STATE OF NEW YORK DEPARTMENT OF PUBLIC SERVICE

CHANGE NOTICE

SUBJECT: CASE 03-T-1385 - Application of Rochester Gas and Electric Corporation for a Certificate of Environmental Compatibility and Public Need for the Construction of the "Rochester Transmission Project", Approximately 38 miles of 115 Kilovolt Transmission Lines in Multiple Municipalities of Monroe and Wayne Counties.

RECOMMENDATION: Approval of Change Notices 916-5, 6, 7 & 13A-4.

## Sheet 8:

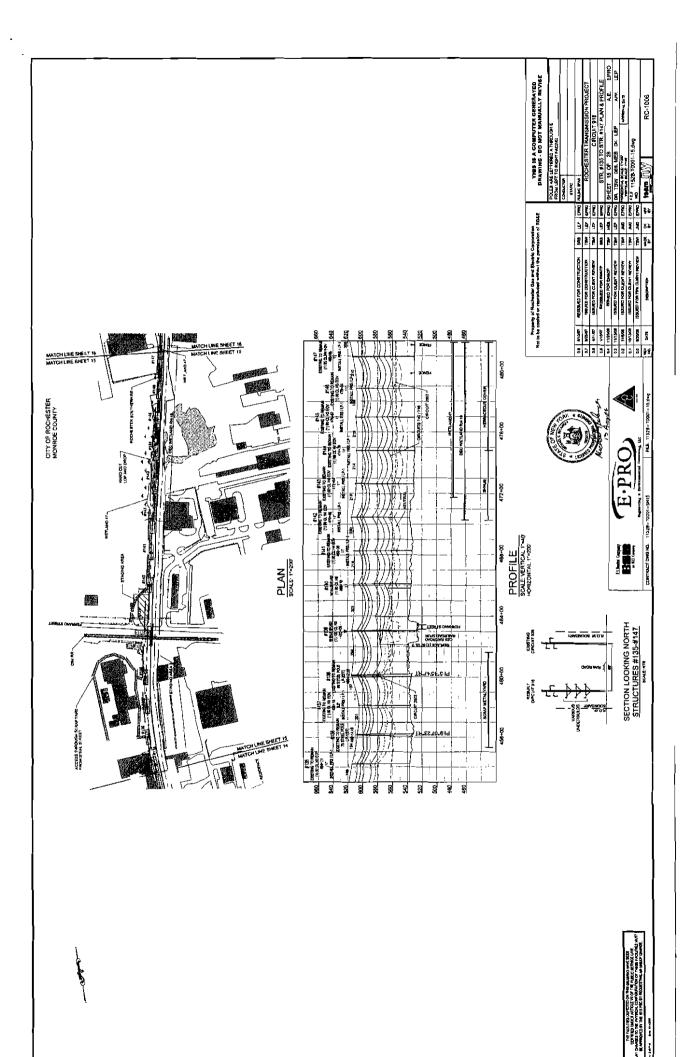
Change - Install additional mats from the work pads at Structures 55 - 61.

**Reason** – Required for access to remove pole butts from previous construction in Wetland 39.

**Change** – Relocate access road between Structures 66 – 71. Install mats along access road in Wetland 41.

**Reason** – New access will partially follow an existing road and increases the distance of the access from the pond located in the vicinity of Str. 67. Continuous access along the ROW between Str. 68-71 will allow for more efficient construction.

## Sheet 16:

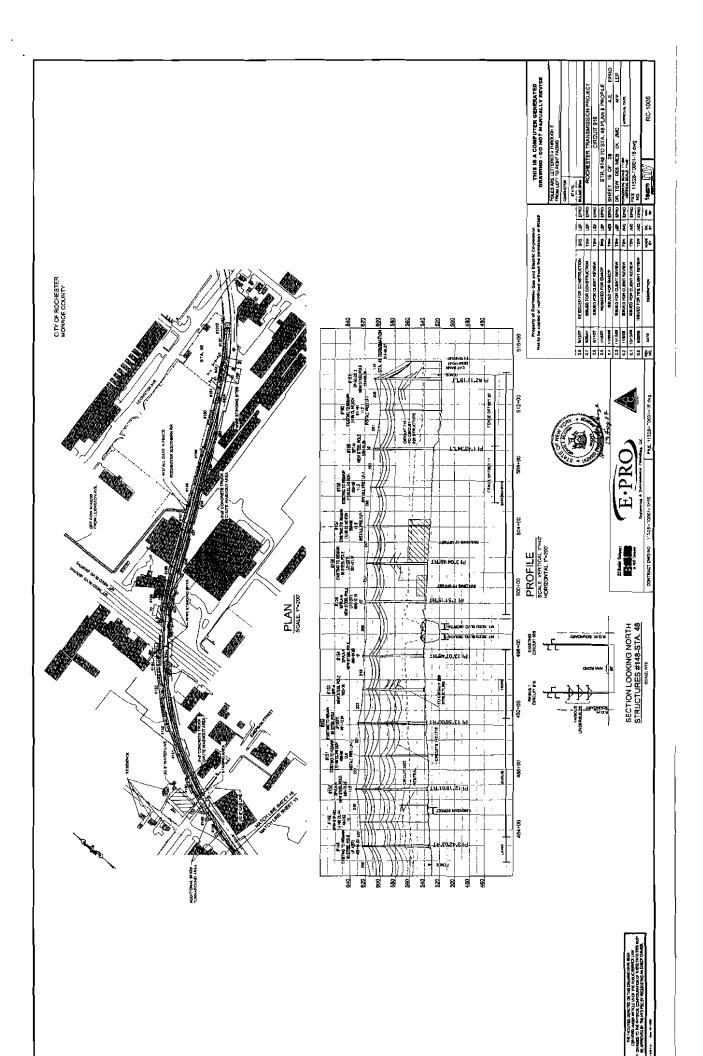
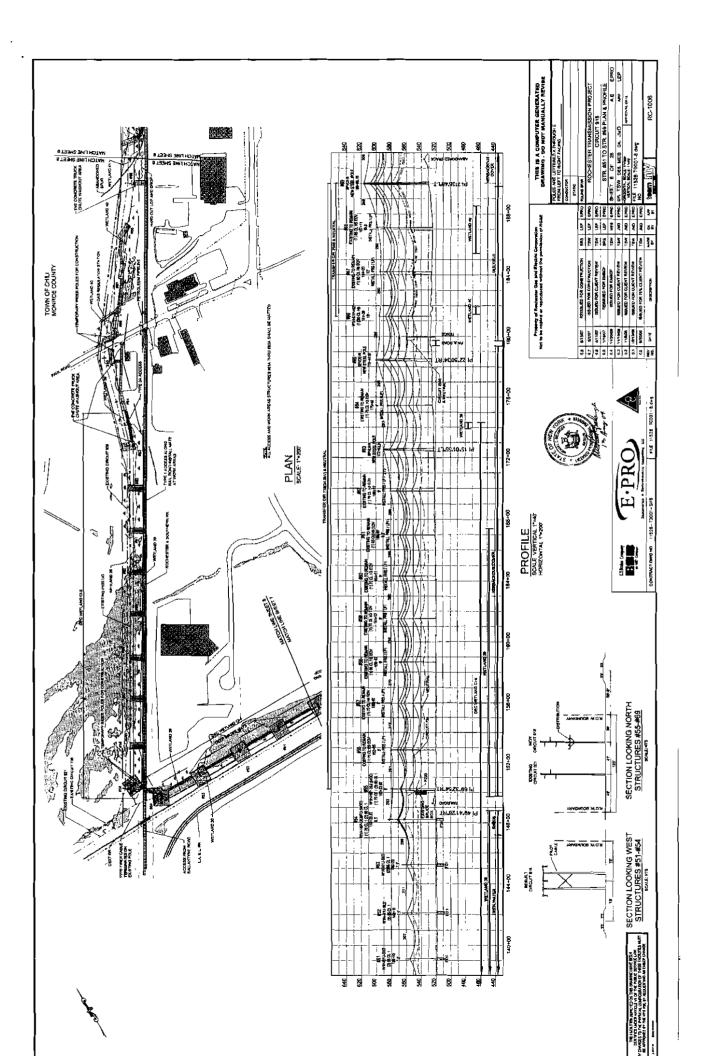
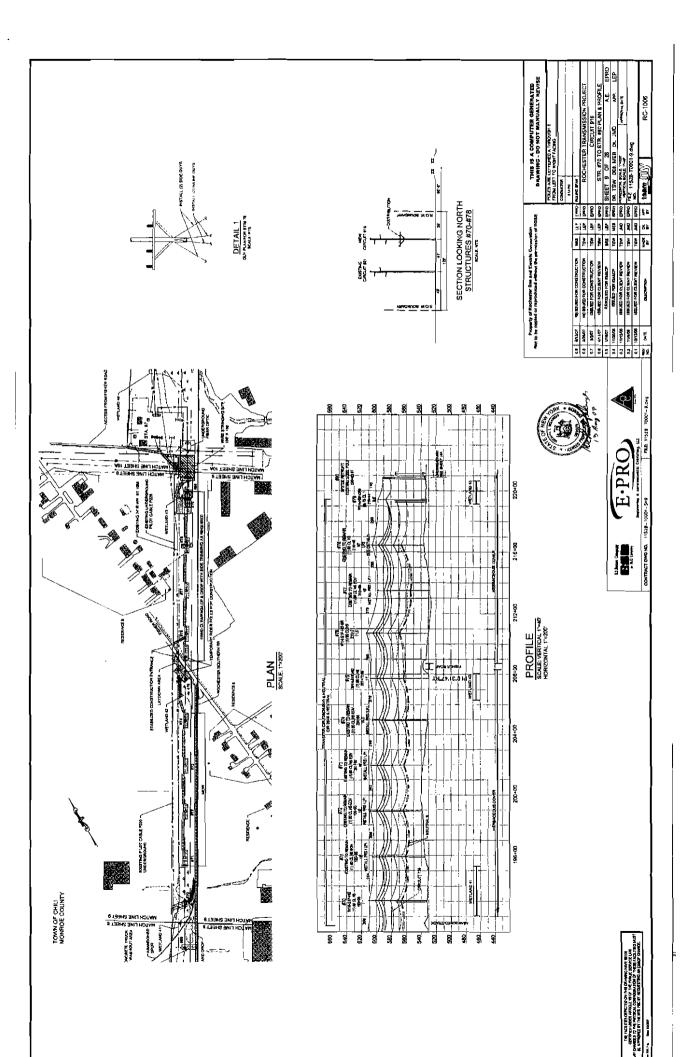
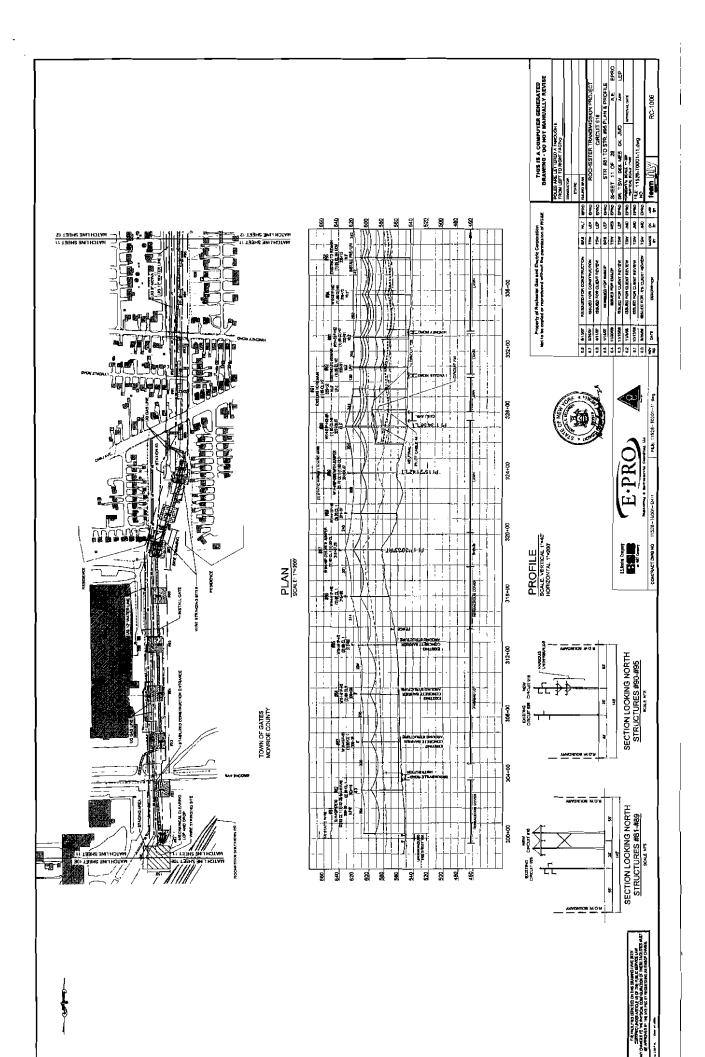
**Change** – Relocate off ROW access from Emerson Street to Str. 147-148. Install a new gate in fence line between Str. 147-148. Move access road between Str. 148-149 to west side of ROW.

**Reason** - The new access alignment will avoid debris present along the original access road, avoid access across a lawn and provide a safer entrance and exit to Emerson Street for construction vehicles.

Change – Add an off ROW access from Lexington Ave. to Str. 153.

**Reason** – This access alignment will facilitate drilling and construction equipment access to Str. 153 & 154, and will minimize the amount of debris removal that may be required along the ROW to facilitate access and construction.

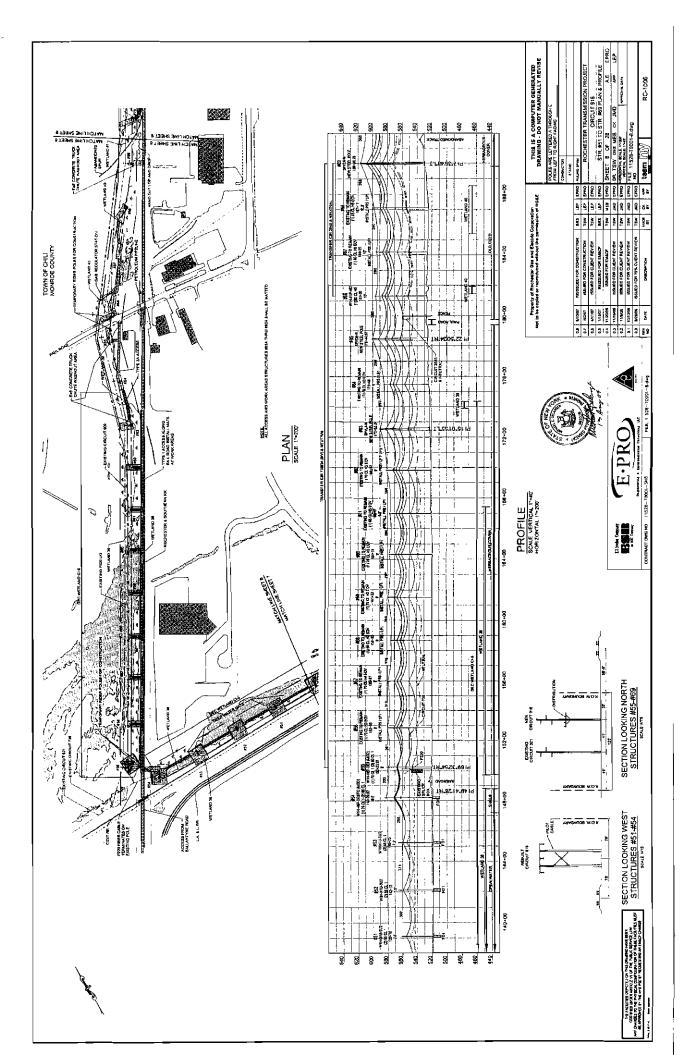
RG&E: K. Doern 10 DPS Staff: \_\_\_\_\_ LOCATION OF CHANGE: SHEET: 8 of 28 CENTERLINE STATION: <u>148+00 to 150+00</u> DRAWING NO: 11528-T0001-8 **DESCRIPTION OF PROPOSED CHANGE:** (include engineering and environmental aspects) Add a 170' x 130' wire stringing site at Str. 55 on Circuit 916 and add a 30' x 50' lay-down area south of Str.55. (Attach copy of proposed change marked on drawing or in EM&CP text) **REASON FOR CHANGE:** The wire stringing site was not identified on the original plan & profile drawing. The lay-down area is needed to for the materials associated with the wire pulling operation. \_\_\_\_\_
